SUBJECT: DENIAL, WELLFIELD UNIT 1 GROUND-WATER RESTORATION
APPROVAL, CROW BUTTE RESOURCES *IN SITU* LEACH FACILITY,
LICENSE NO. SUA-1534 (TAC No. L52376)

Technical Evaluation Report

FACILITY: Crow Butte Resources *In Situ* Leach Uranium Project, Chadron, Nebraska

FIGURE 1. Unit 1 Radium-226 Measurements

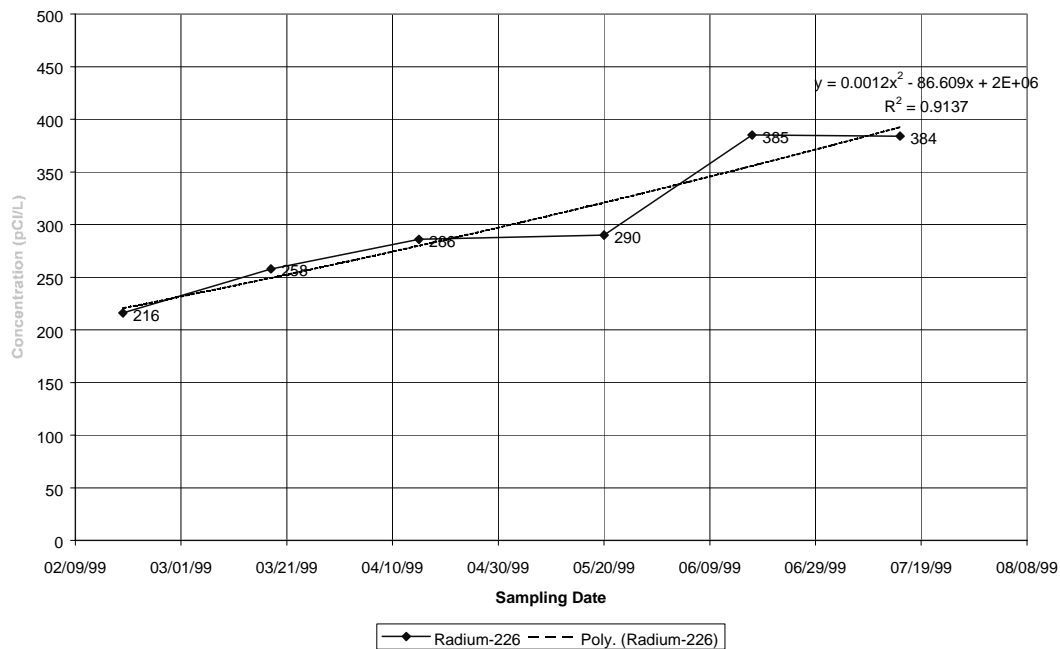
1. **Finding:** Staff’s analysis indicates that concentrations of ammonium, iron, radium-226, selenium, total dissolved solids, and uranium show strongly increasing concentration trends over the stability monitoring period. These trends indicate a reasonable likelihood that license limits would be exceeded in the near future. Other constituents appear to have reached stability, or exhibit such a weakly increasing trend that stability is not a concern. Figures 1, and 2, provide examples of strongly increasing concentration trends in the monitored data during the stability monitoring period. These increasing trends represent a particular concern when a constituent has been restored to the secondary restoration goal, as these two examples were. The secondary restoration standards are greater than the pre-operational baseline concentrations, but are considered protective of the adjacent aquifer beyond the limits of the U.S. EPA designated aquifer exemption boundary. Increasing trends that indicate a potential future exceedance of baseline limits do not represent an immediate concern, since the secondary limits are higher than the baseline limits and are considered protective. Figures 3, and 4, illustrate two constituents that appear to have stabilized during the stability monitoring period. Although Figure 3, shows an increasing trend, this trend is not significant. Figure 4 shows a strongly increasing trend in the early measurements, but the trend dissipated by the time the later data were collected.
